## ***Interactive comment on “A coupled Bayesian and fault tree methodology to assess future groundwater conditions in light of climate change” by J. J. Huang et al.***

**J. J. Huang et al.**

Received and published: 26 October 2014

Fig. 1.

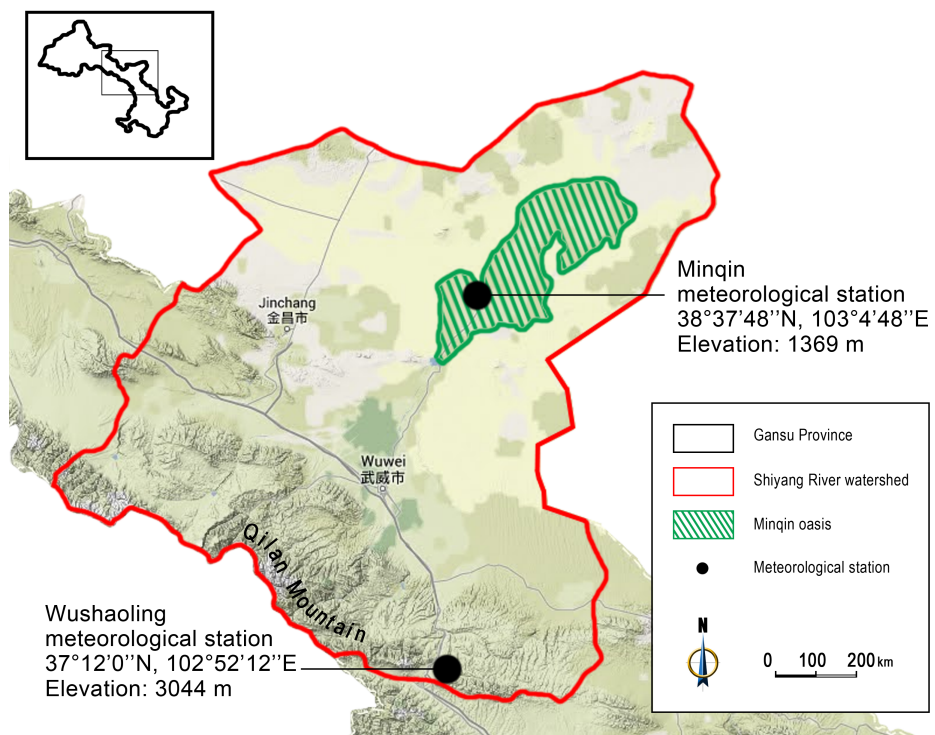
Comment 16

Figure 1 – It should focus on the area of the case study

A: Figure 1 have been revised as suggested
